ARESTI AEROBATIC CATALOGUE (CONDENSED) Review of 2017-1 catalogues published by Aresti System, S.L.

At the CIVA 2017 plenary conference some figure revisions will be discussed for use starting in 2018. A number of errors have also been identified in the 2017 catalogues that should be resolved before new versions of the Aresti Catalogue (Condensed) can be published.

This document indicates the changes to the text and diagrams that will be required if plenary approval is granted.

Family 7

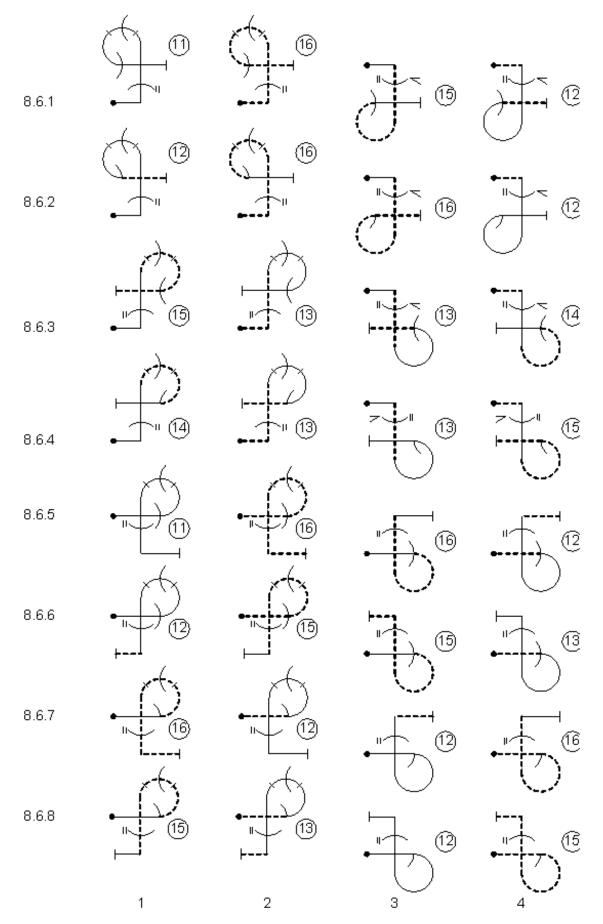
In the existing catalogue the K Factors appear correct, but in 7.8.17.4 is not centred in its circle (suspect space in front of number).

Family 8 errors

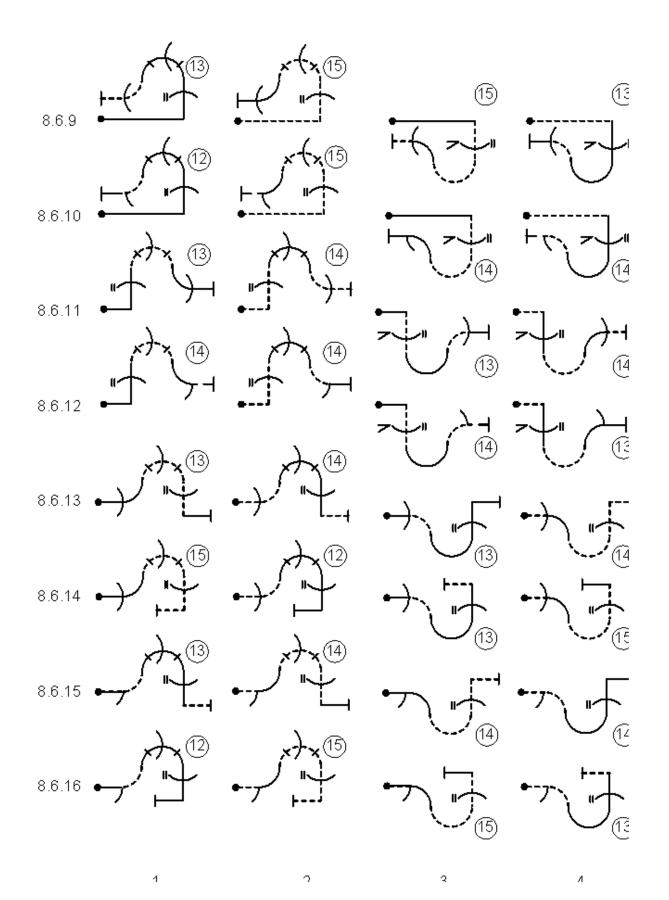
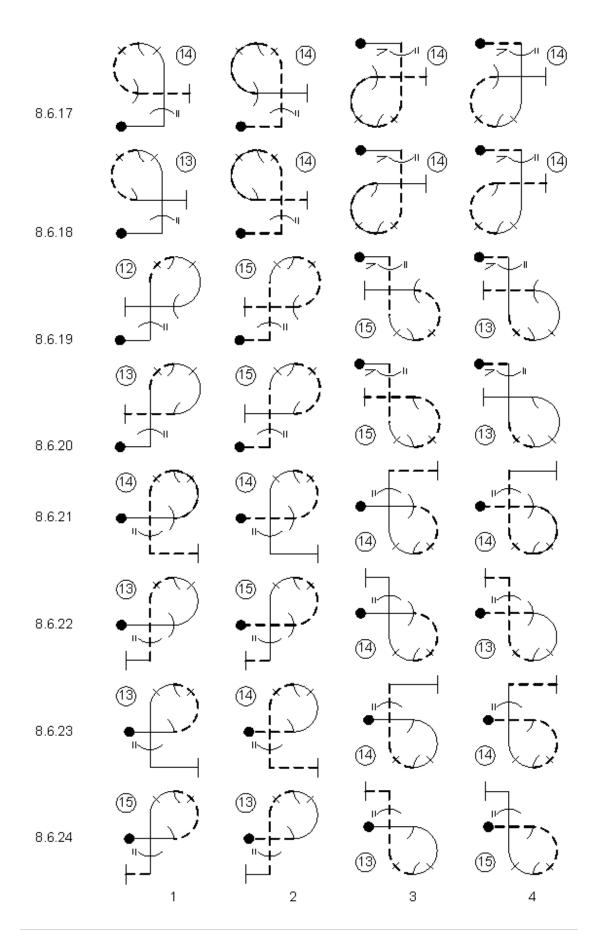
- 8.6.6.3 and 8.6.6.4 The existing items erroneously change sense (positive/negative) at the lowest point
- 8.6.13.2, 8.6.13.4, 8.6.14.2 and 8.6.14.4 The existing items omit the entry line full roll
- 8.6.24.3 and 8.6.24.4 The existing items have their exit lines in the wrong directions and with their erect / inverted sense reversed
- 8.7.6.2 This is shown the same as 8.7.6.1 but should start inverted and go upwards

FAMILY 8.6 - P Loops with apical half rolls

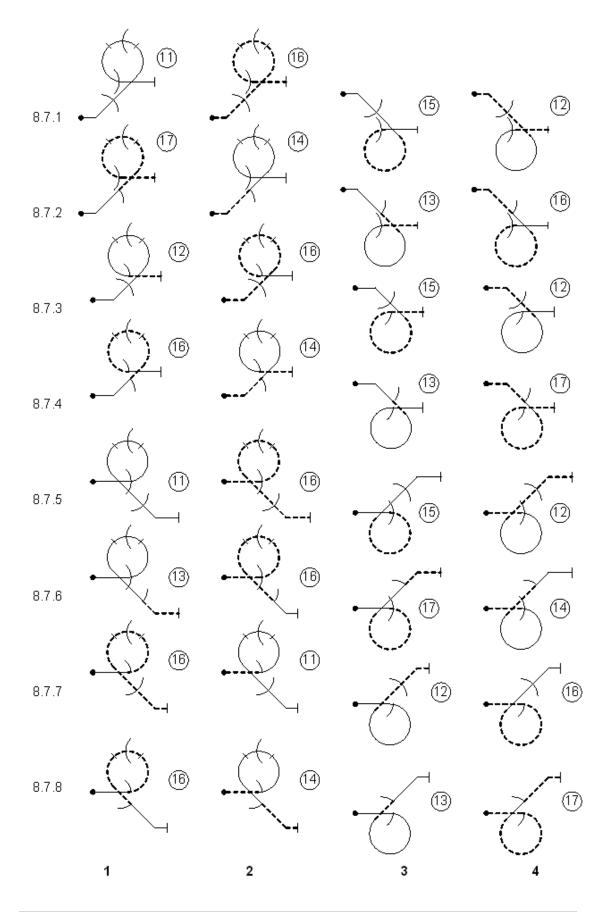
• 8.6.17 to 8.6.24

All items on the existing catalogue page have their vertical roll or spin elements omitted. When the entry or exit line is horizontal with a full roll opportunity, this symbol is also missing. The changes to these items have been approved by CIVA at its 2017 plenary conference. FAMILY 8.6 - P Loops (6/8ths Looping Segment)

• 8.7.6.2

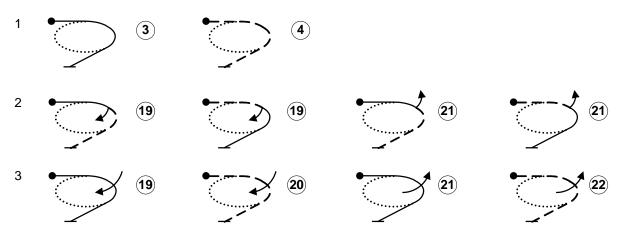
This is shown the same as 8.7.6.1 but should start inverted and go upwards, as displayed on page 5 in the power section above

Family 2 errors (90° and 180° Turns)

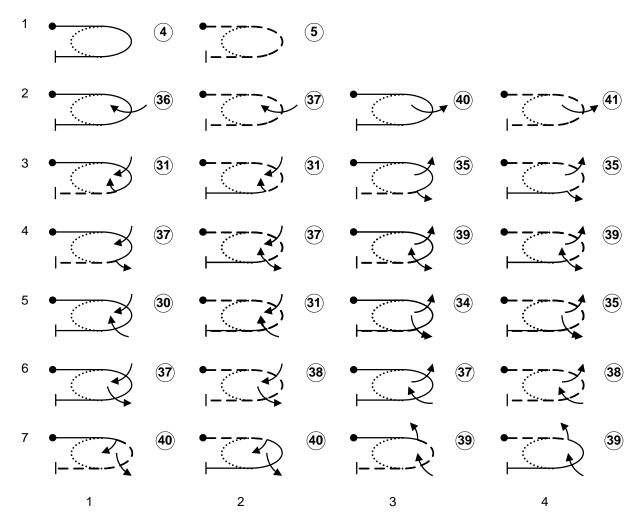
- 2.1.2.1 to 2.1.3.4 All items as currently published have the power K values instead of the correct glider values
- 2.2.2.1 to 2.2.7.4 All items as currently published have the power K values instead of the correct glider values

8.6 "P" LOOPS

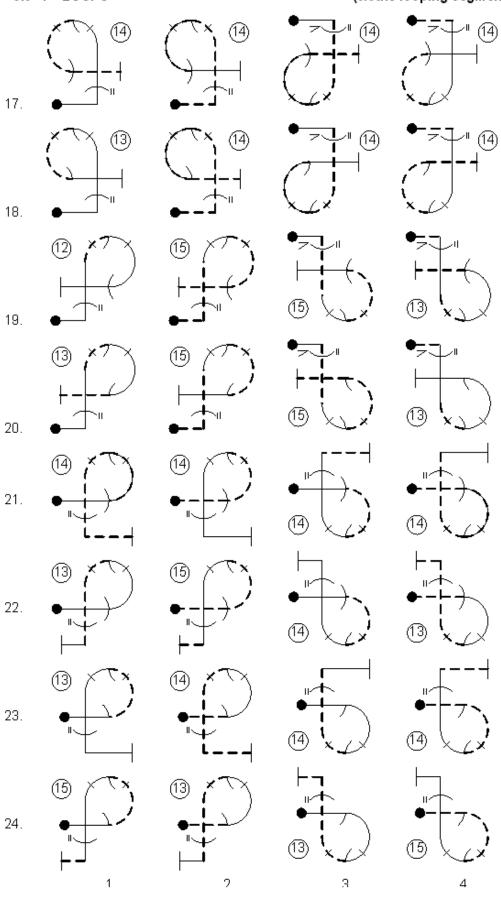
- 8.6.6.3 and 8.6.6.4 The existing items erroneously change sense (positive/negative) at the lowest point.
- 8.6.13.2, 8.6.13.4, 8.6.14.2 and 8.6.14.4 The existing items omit the entry line full roll (see the power diagrams, though the glider K-Factors are already correct).
- 8.6.24.3 and 8.6.24.4

The existing items have their exit lines in the wrong directions and with their erect / inverted sense reversed
